Project: BRIDGE REPLACEMENT CAVENDISH, VT

Drawing: ABUTMENT AND APPROACH SLABS

CAVENDISH ER BRF 0146(13)

REINFORCING PLAN

APPROACH SLAB #1

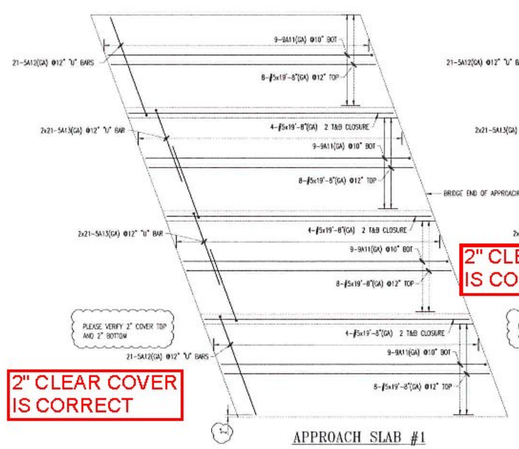
PLEASE VERIFY COVER AND LAP OF DWL BARS

DB SUBS ON N.F. SHOULD BE EQUALLY SPACED BETWEEN THE GIRDERS

AND TO AVOID CONFLICT WITH ADJACENT GIRDERS

FIELD CUT DWL BAR SUBS AS NEED TO ACCOUNT FOR WINGWALL SLOPE.

APPROACH SLAB #2

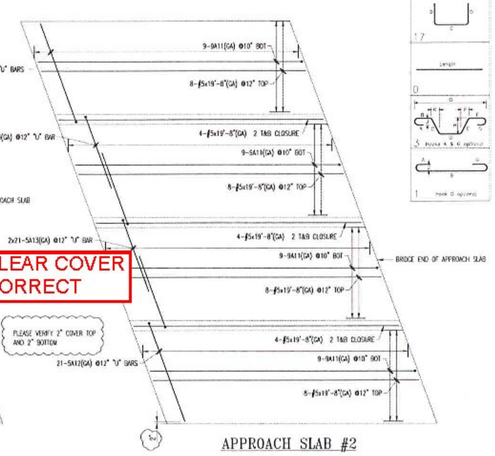
DB SUBS ON N.F. SHOULD BE EQUALLY SPACED BETWEEN THE GIRDERS
